Plan Change Request

➤ Specify the approved civil plans affected: C5-101, C5-201, C5-202, C5-201, C6-101, C6-201

Project:
**WSF Gold Gate
 Redevelopment**
 Civil Construction
 Permit

WATER & SEWER VENDOR CONNECTION
 DETAIL A
 1" = 1' C5-201

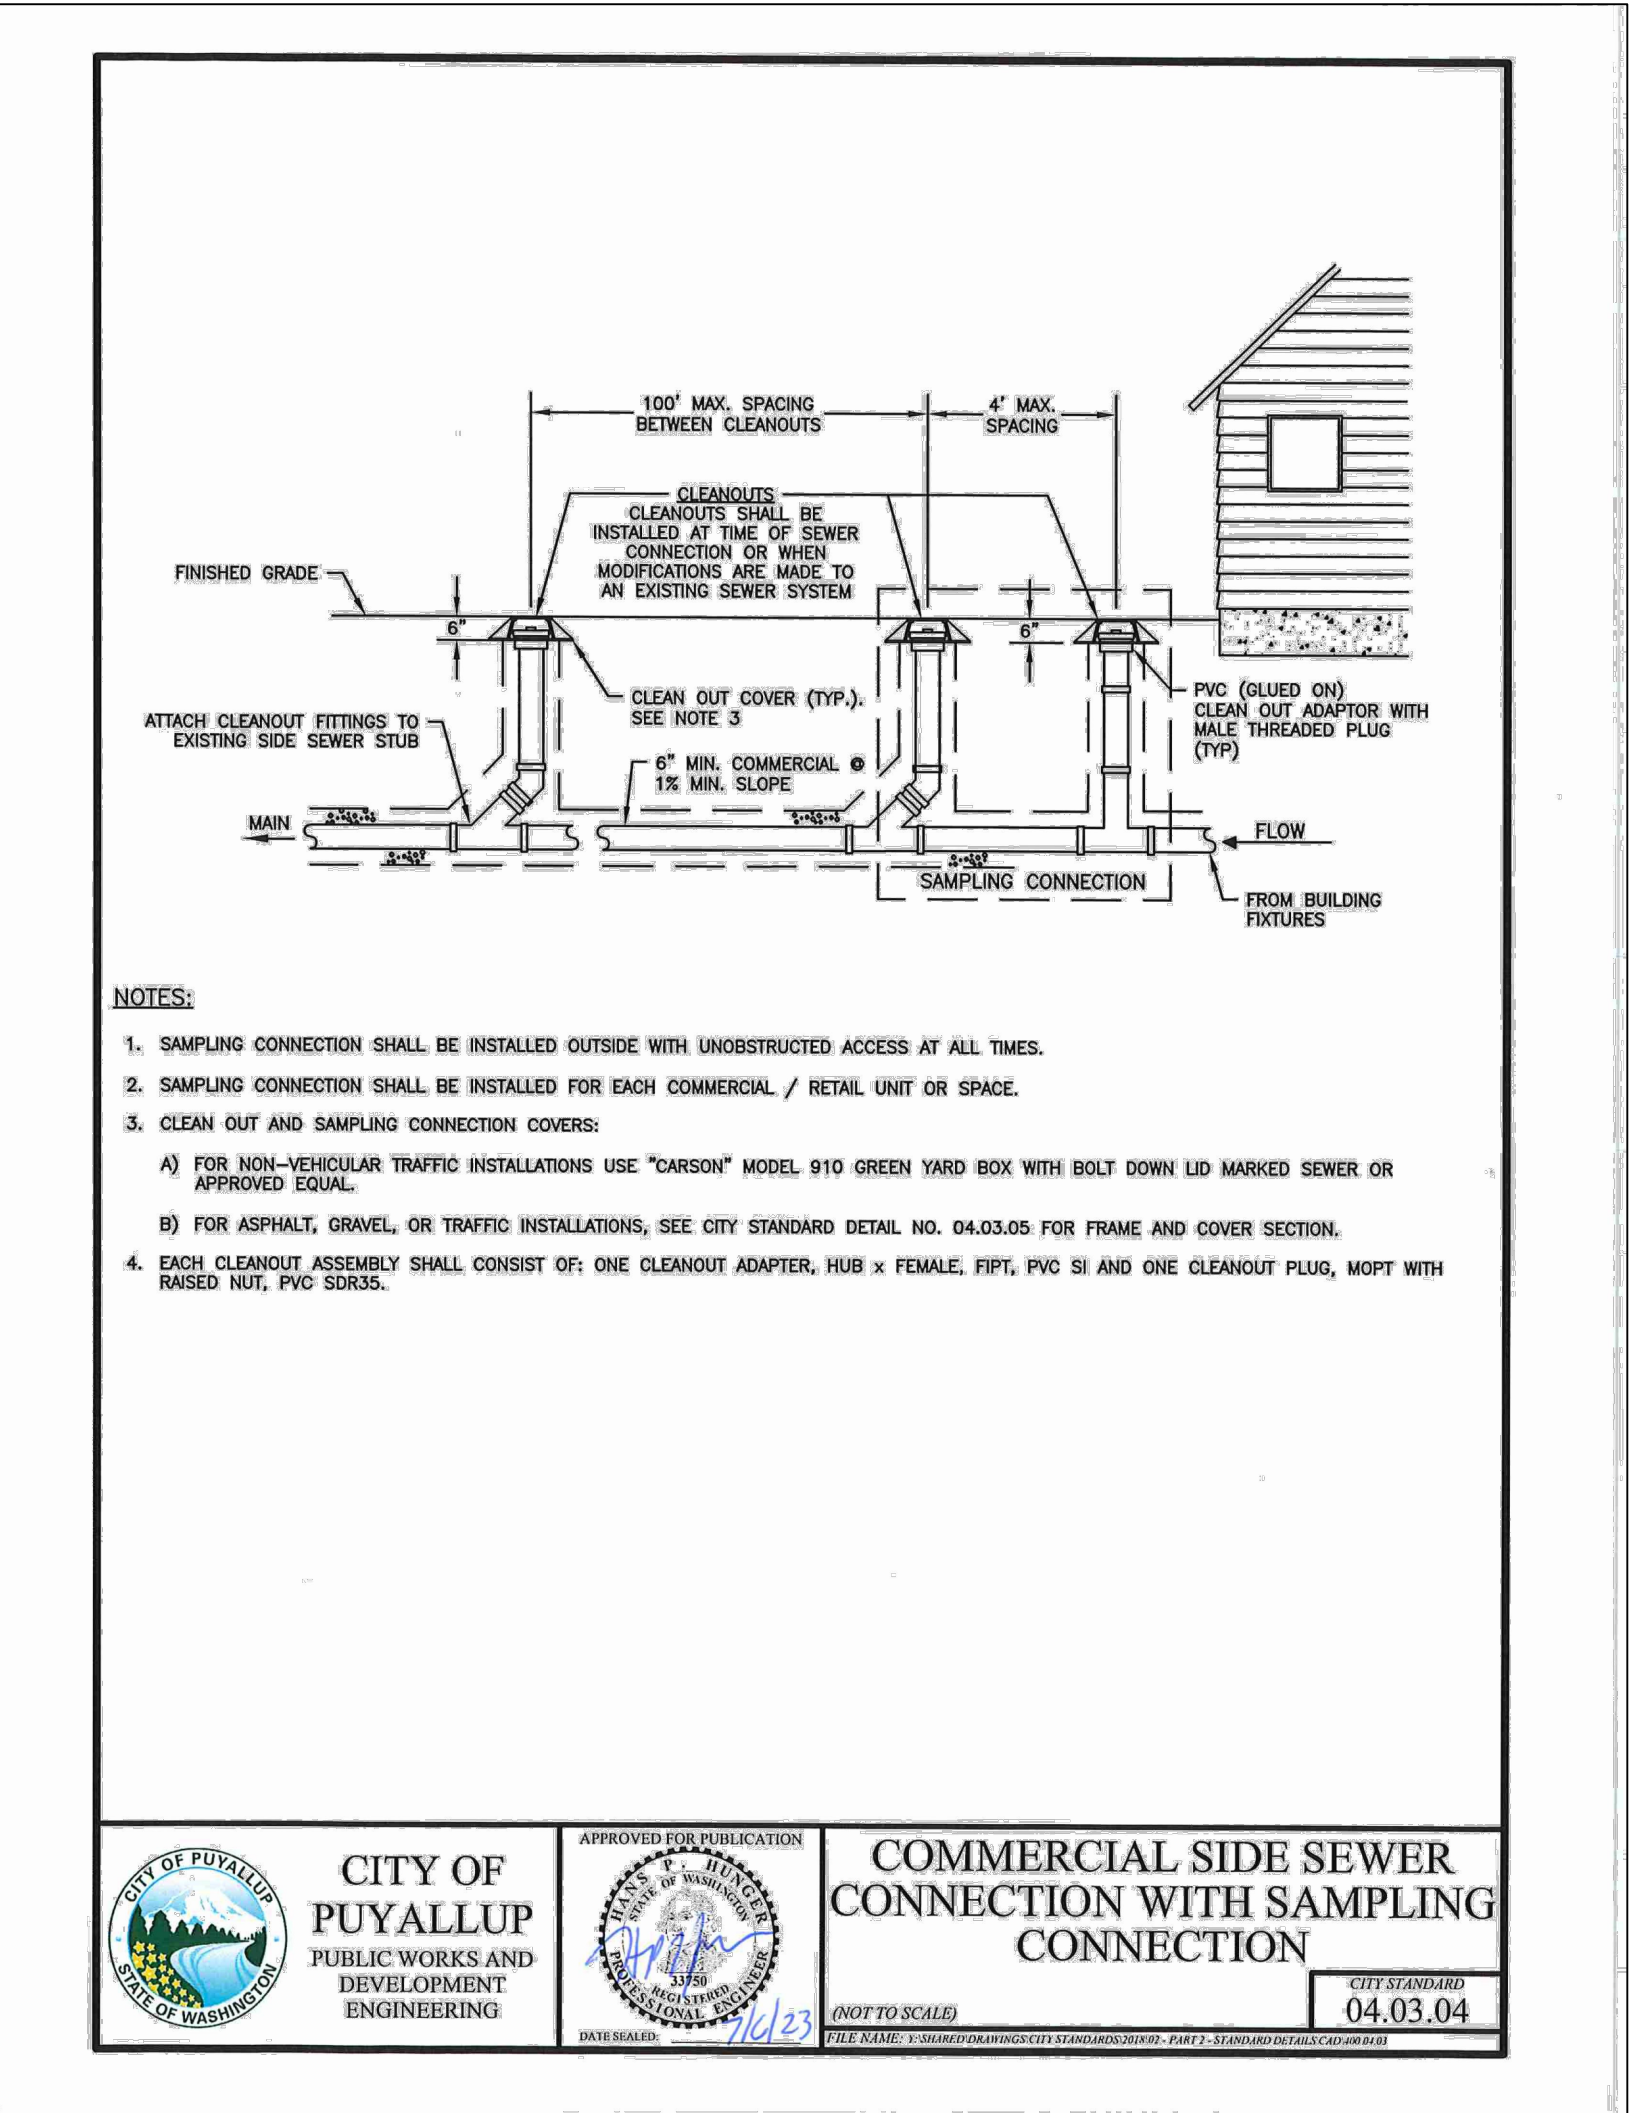
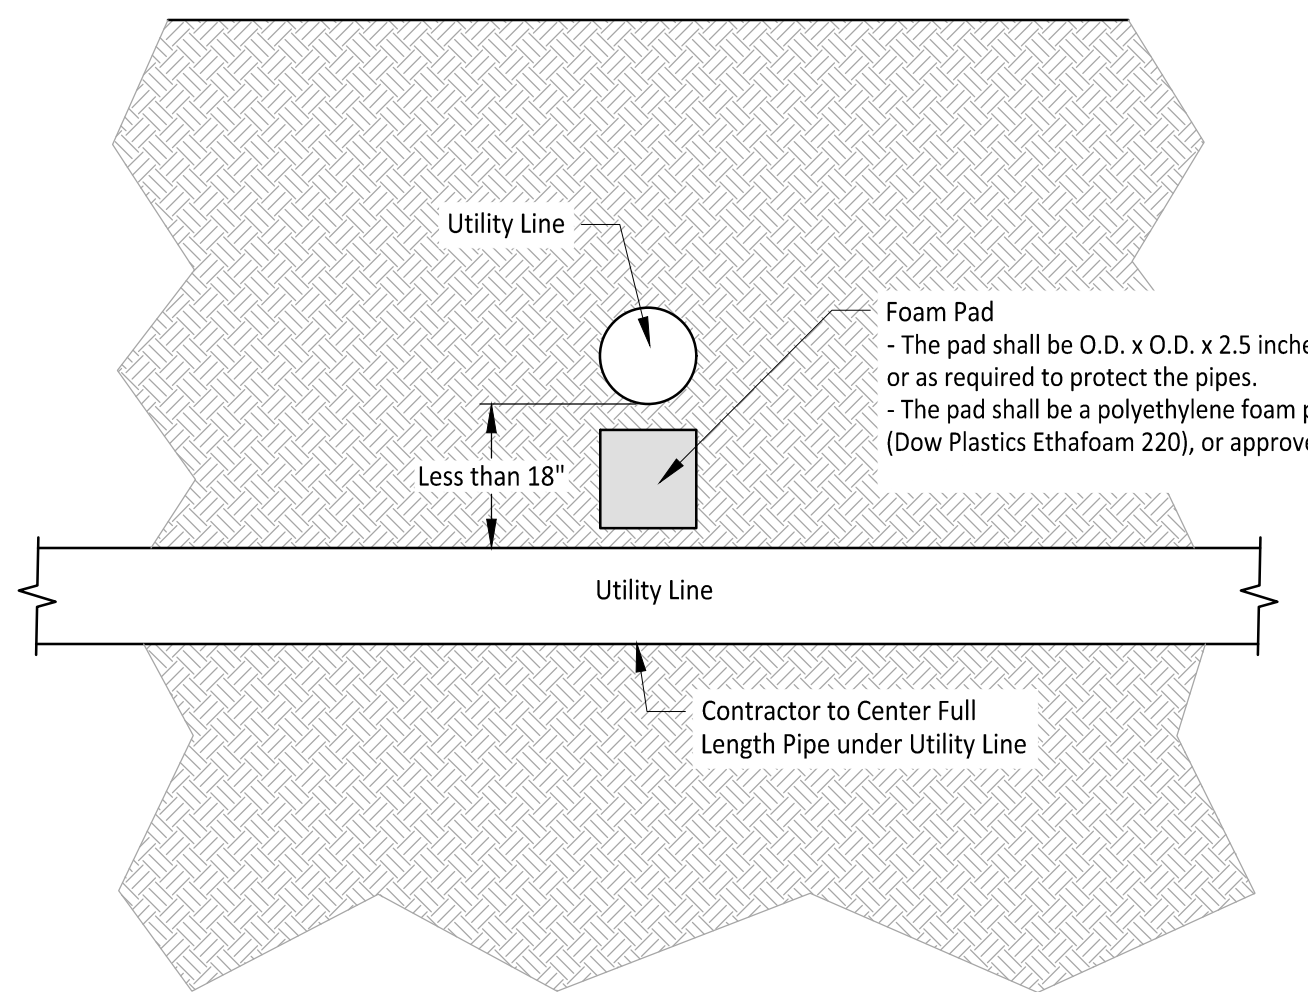
- NOTES**
- Hose bibs and sewer connections to be no more than 6" below vault lid.
 - Water vault lid to have two inch hole above each hose bib.
 - Sewer vault lid to have to have four-inch hole directly above 2" to 4" PVC reducer.
 - Vault to be Type 3 24" by 36" with one 12" riser and two diamond plate double hinged H20 rated lids.
 - Bottom of vault to be backfilled with pea gravel.
 - All pipe clamps to be stainless steel.

- Hose bibs and sewer connections to be no more than 6" below vault lid.
- Water vault lid to have two inch hole above hose bib.
- Sewer vault lid to have to have four-inch hole directly above 2" to 4" PVC reducer.
- Vault to be Type 3 22" by 32" with one 12" riser and one diamond plate double hinged H20 rated lid.
- Bottom of vault to be backfilled with pea gravel.
- All pipe clamps to be stainless steel.
